Historic Preservation Board File No. 25-0676

2201 Collins Avenue

Presentation by Law Offices of Kent Harrison Robbins, P.A.
on behalf of the Roney Palace Condominium Association, Inc.

March 17, 2026

CONSTRUCTION ON OCEAN AND DUNE OVERLAY AREAS

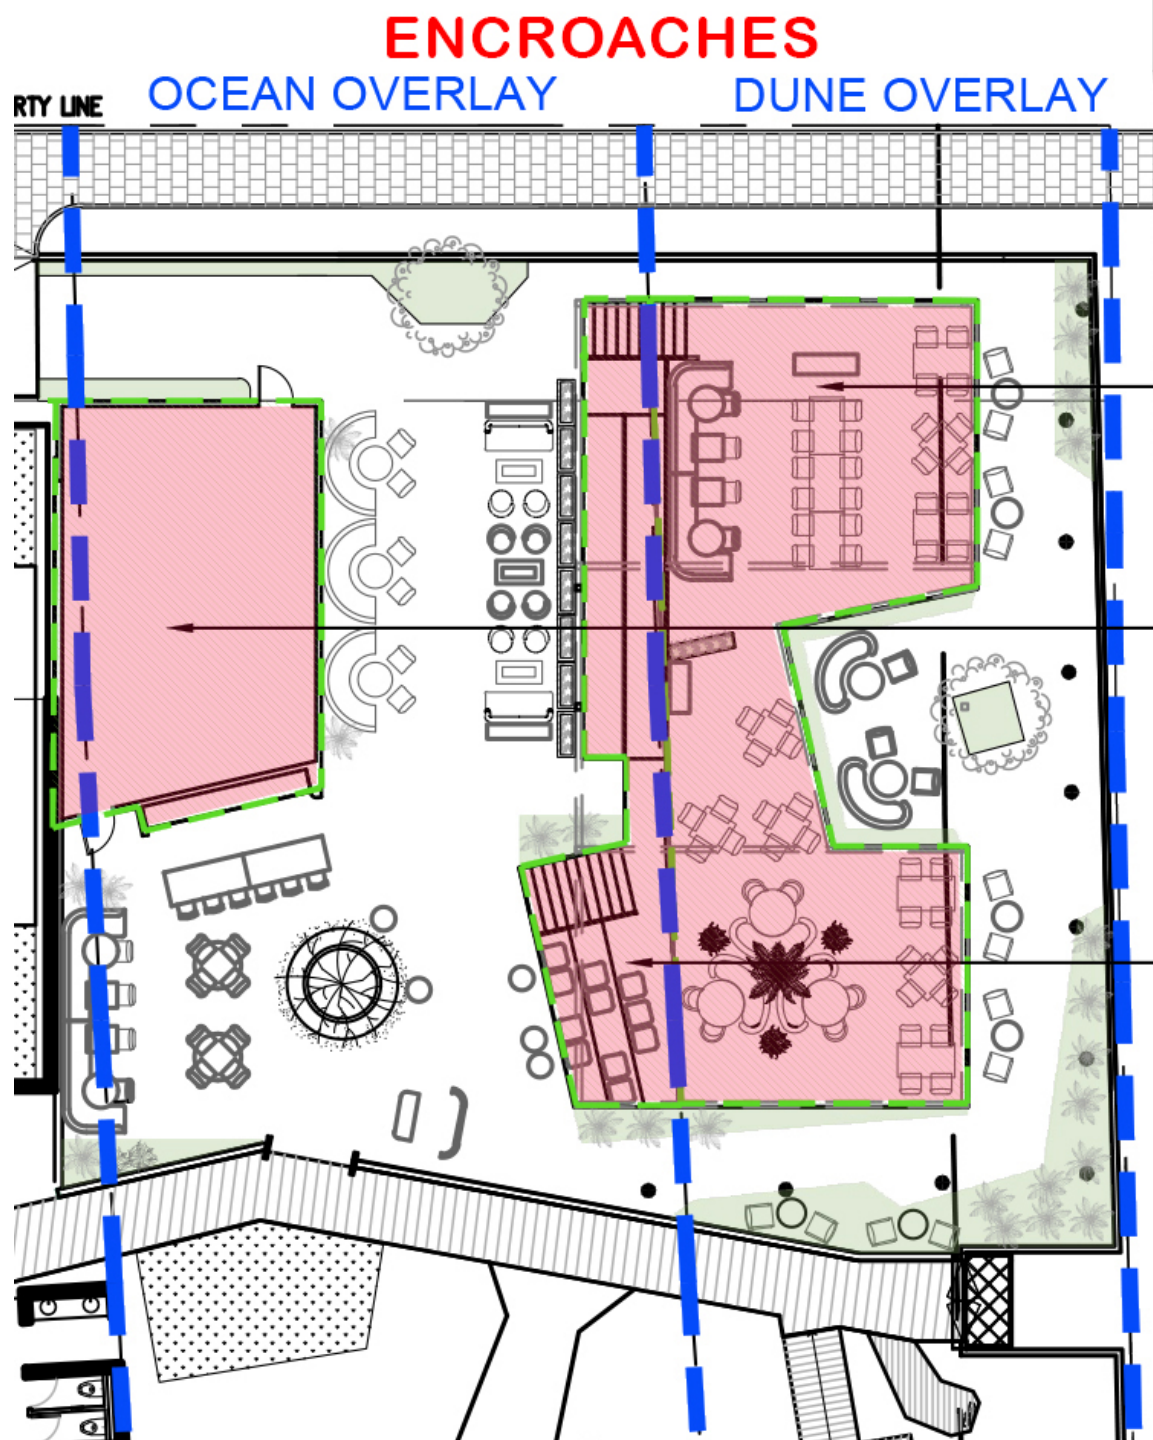
New Restaurant
New Outdoor Bar
New Seating - 237

NEW DECK AREA
WITHIN DUNE
OVERLAY
= 1,598 SQ.FT.

NEW FOOD &
BEVERAGE
AREA
837 SQ.FT.

NEW DECK AREA
WITHIN OCEAN
OVERLAY = 539
SQ.FT.

① DECK SECTION - PROPOSED
SCALE: $\frac{1}{8}'' = 1'-0''$

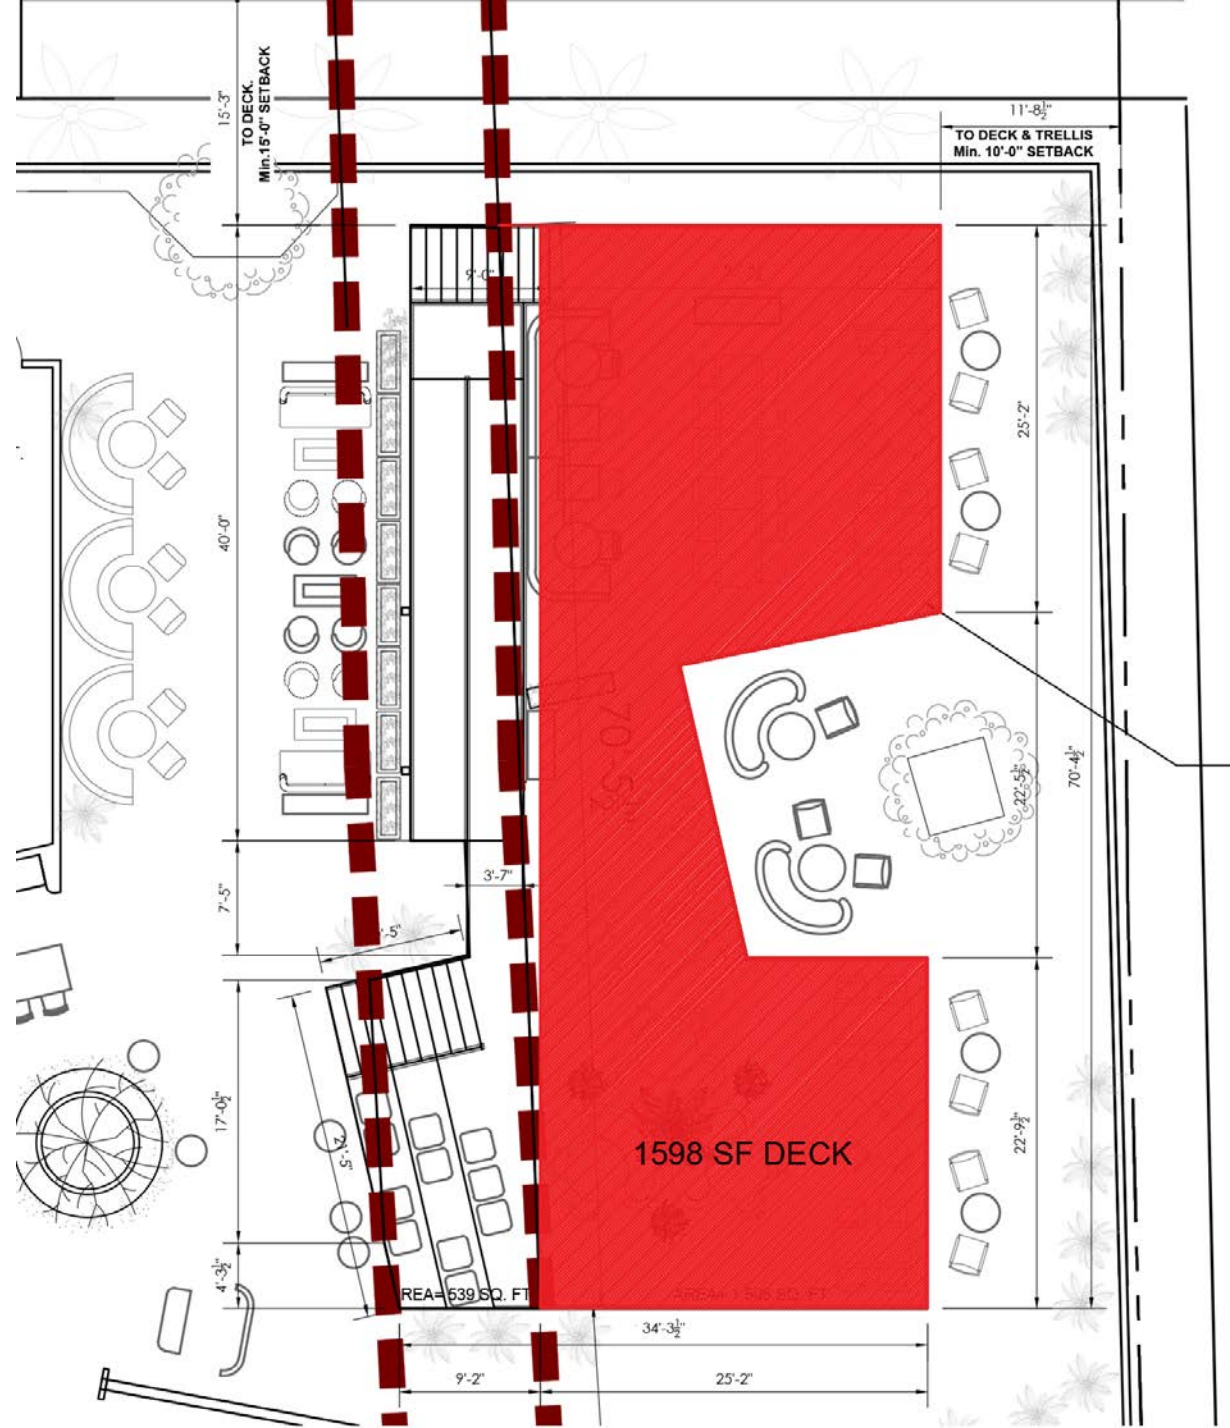
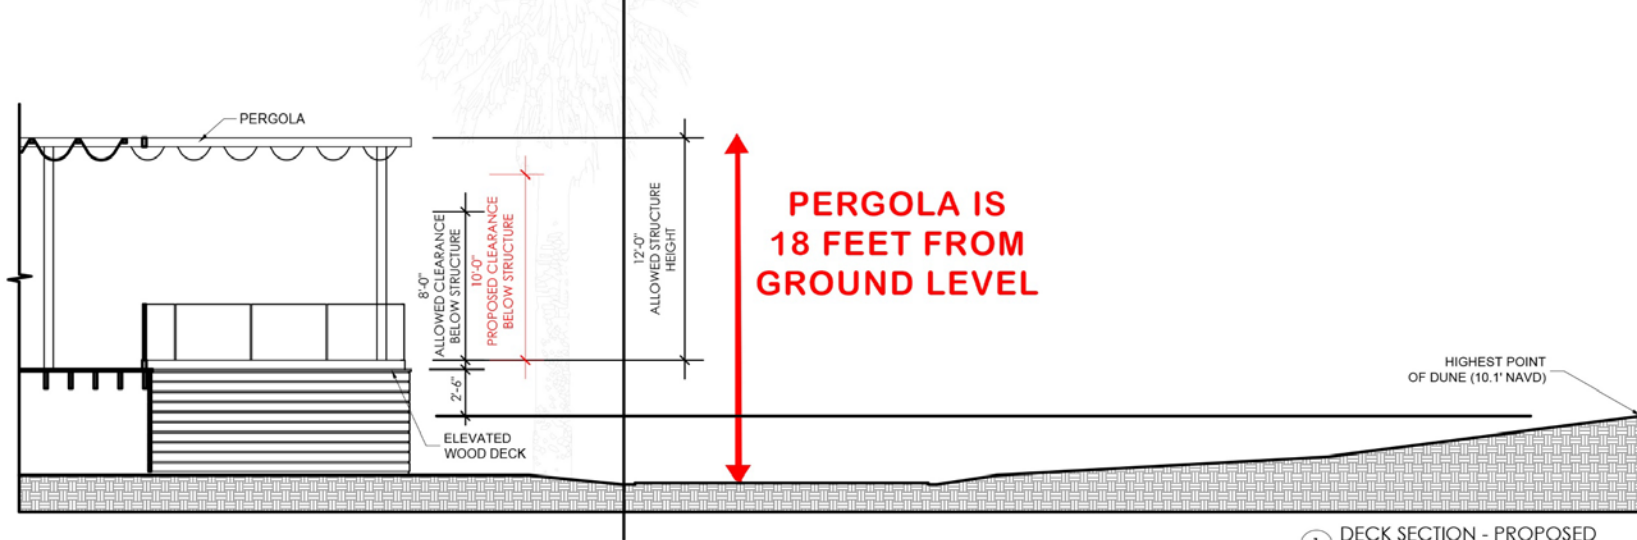
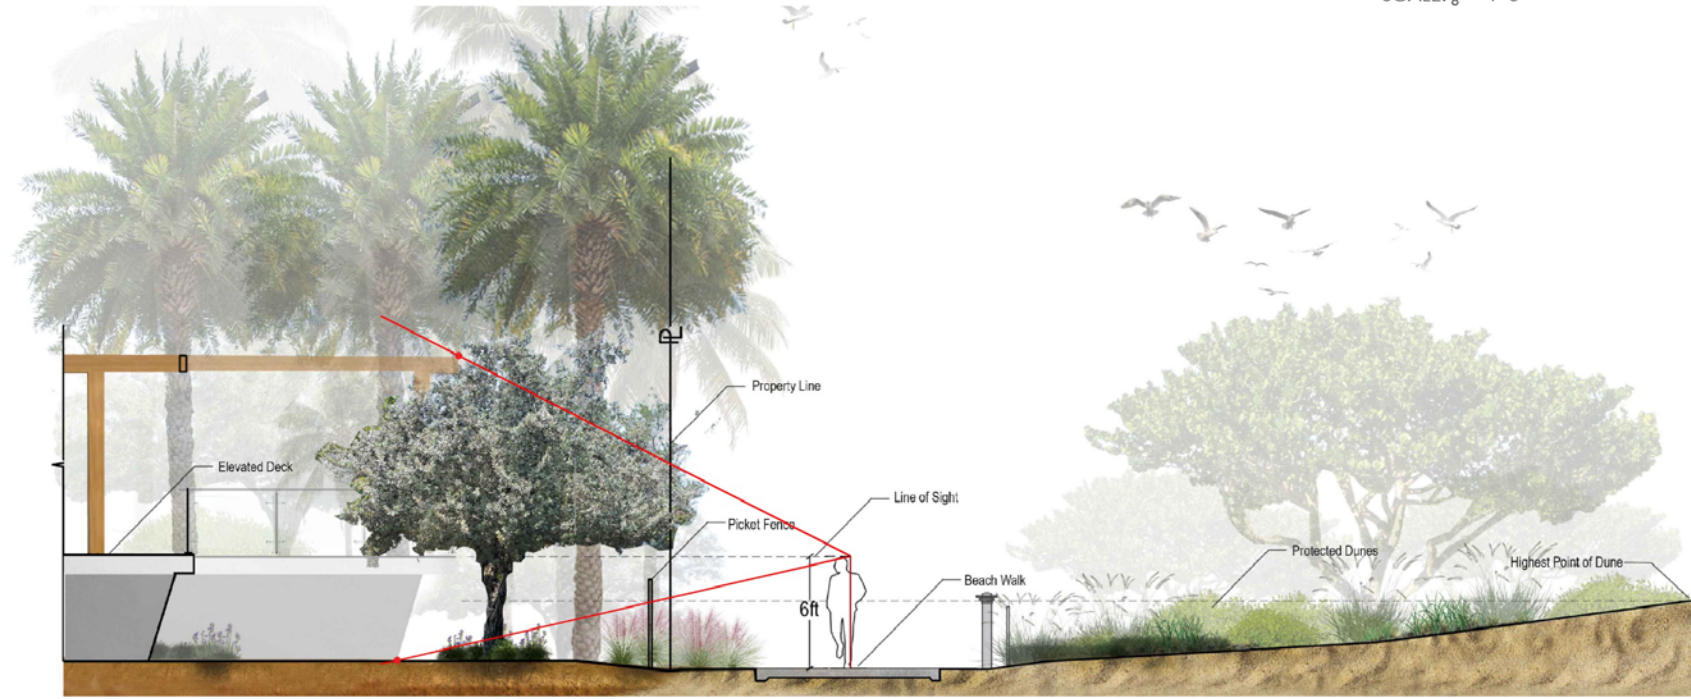
Staff has concerns regarding the concentration of dining area and associated canopy structures proposed within the dune environment. The large retractable canopy structures, combined with the consolidated deck area, represent a significant intensification of covered and enclosed space within an area where the overlay regulations are specifically intended to limit such development.

From Page 11 of the Staff Report

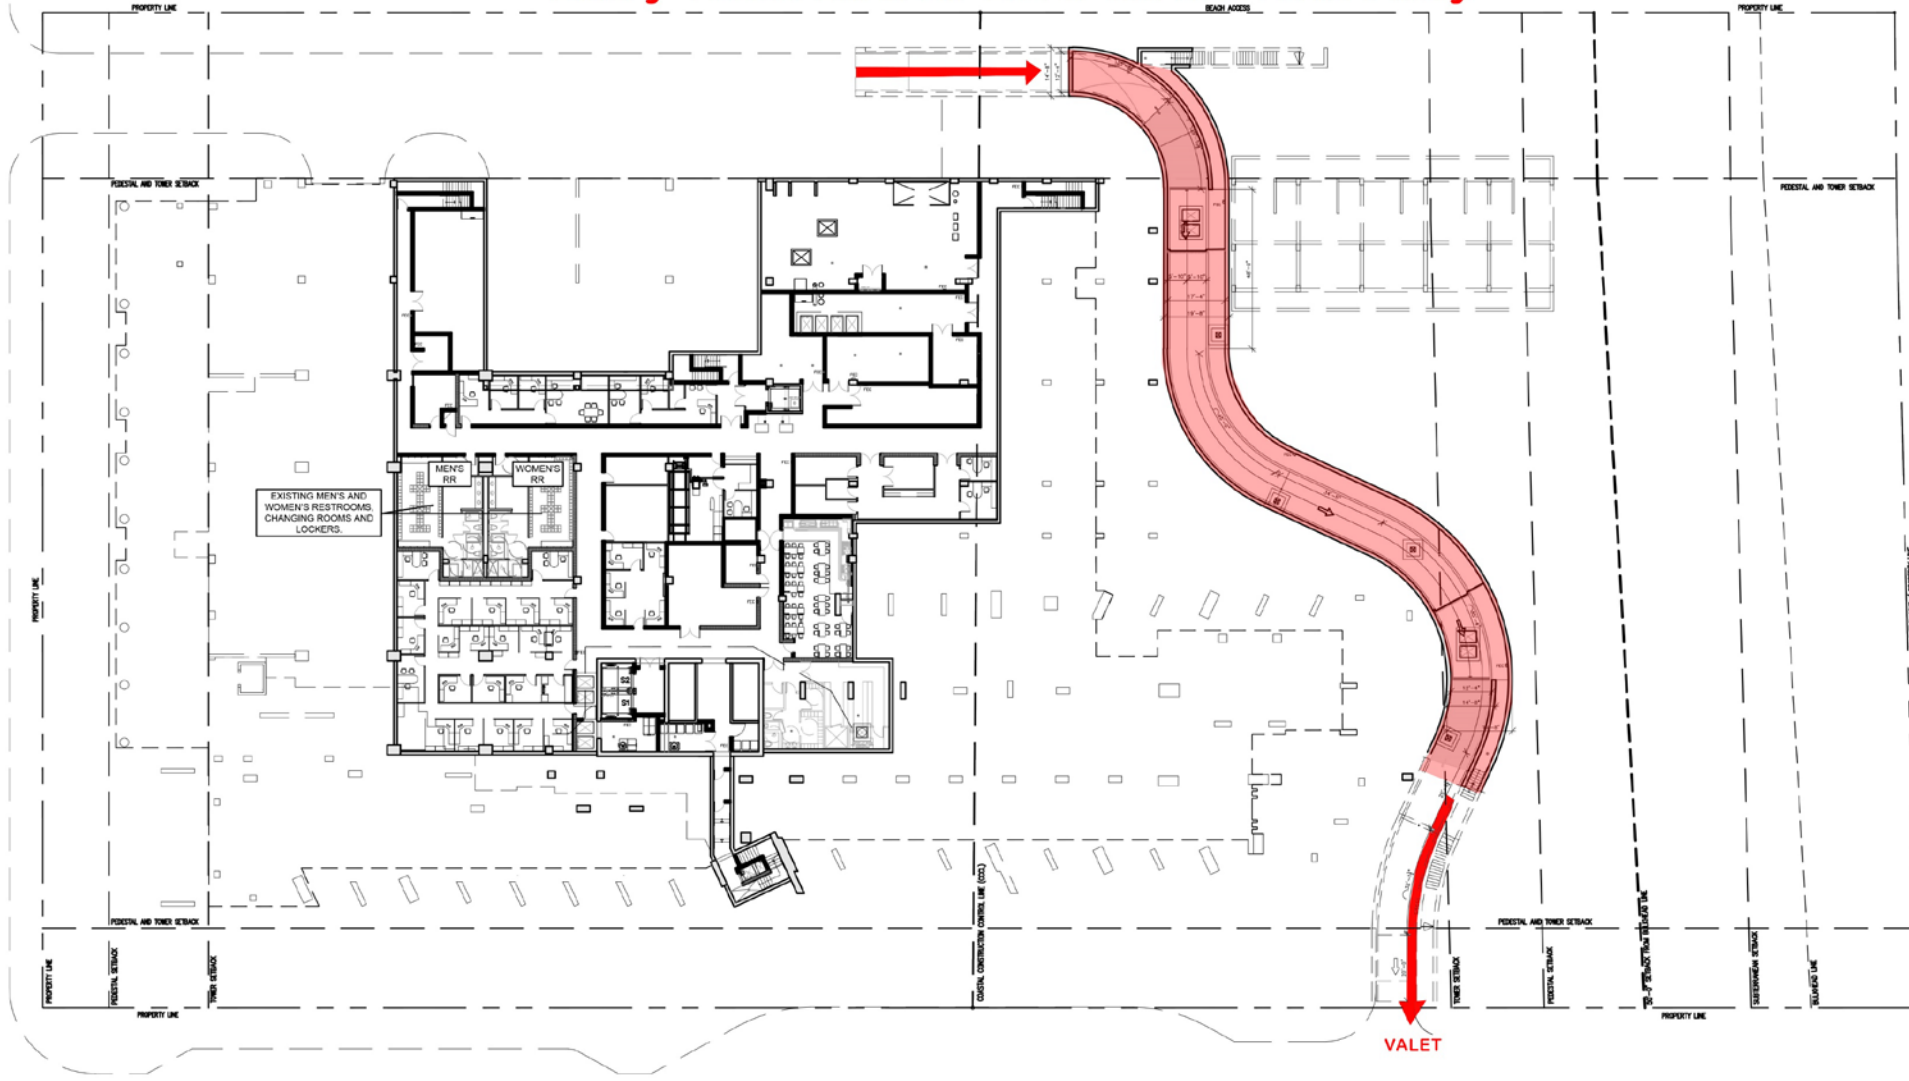
Variance #2 pertains to the maximum permitted height clearance for a shade structure within the Dune Preservation Overlay. The applicant is proposing a trellis system that incorporates a retractable fabric awning, side fabric shades, and a clear glass roof element. The code limits shade structures within the dune area to a maximum height clearance of eight feet. The proposed trellis system has a height clearance of ten feet, exceeding the maximum by two feet. The applicant has not demonstrated that the additional height is the minimum necessary to meet a practical difficulty specific to this property, given that the beachfront location and applicable regulations were established conditions at the time the building was constructed. If the Board determines that the variance is appropriate, staff recommends as a condition that no more than 50 percent of the covered structures exceed the maximum permitted eight-foot height clearance.
